MEMORANDUM

DATE: May 5, 2015

SUBJECT: BZA Case 18962 - request for variance relief pursuant to DCMR 11 § 3103.2 from the requirements regarding nonconforming structures (§ 2001.3) with respect to rear yard (§ 404.1) and accessory uses and buildings (§ 2500.3) to construct a sunroom to an existing single family dwelling at 1211 Kalmia Road, NW.

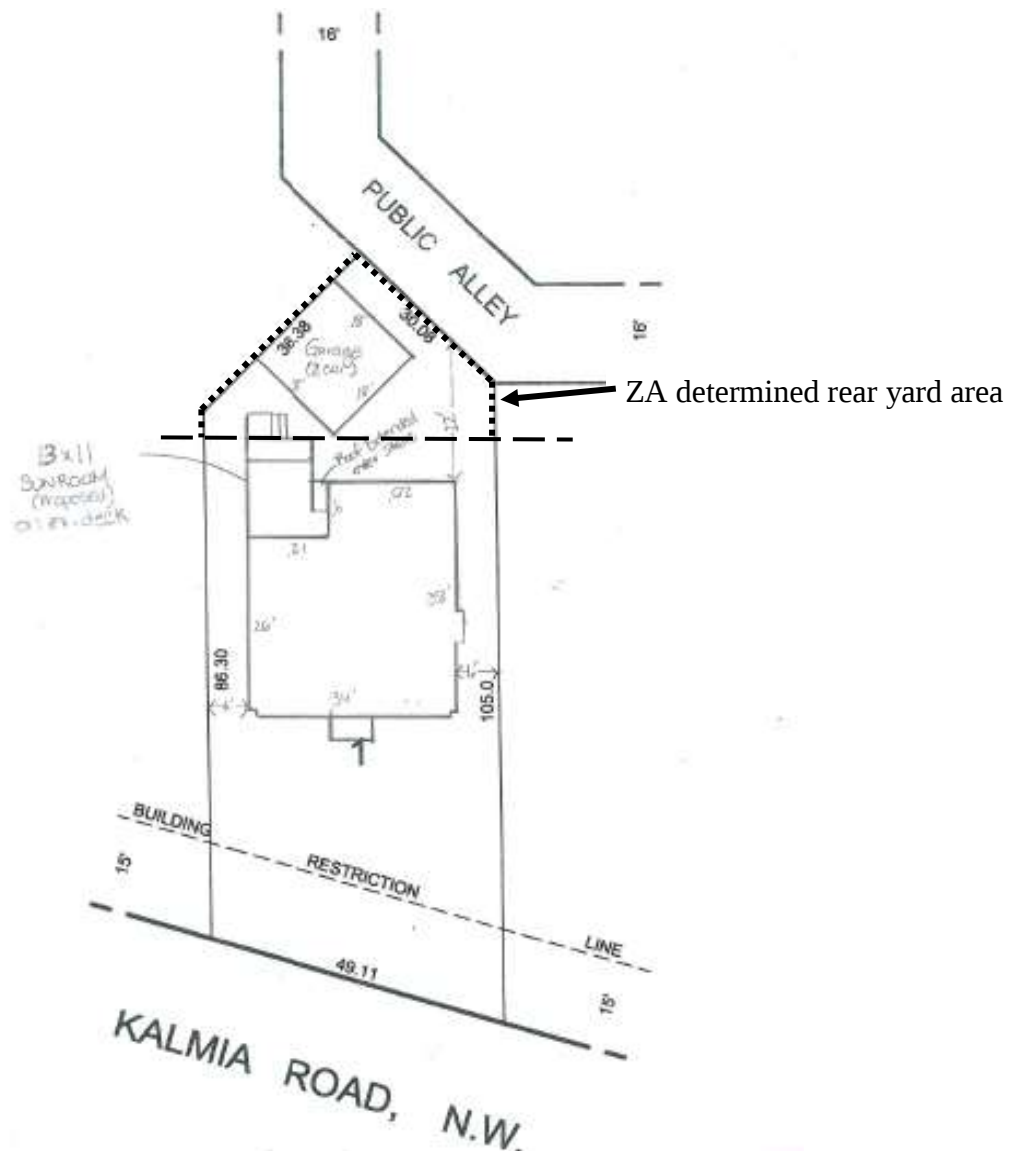
As determined by the Zoning Administrator, the average rear yard measurement is 17.6 feet, where 25 feet is required. The irregular shape of the property combined with the home's location set back well towards the rear of the lot has an impact on the rear yard dimensions, including its area. (As seen in the plat diagram below)
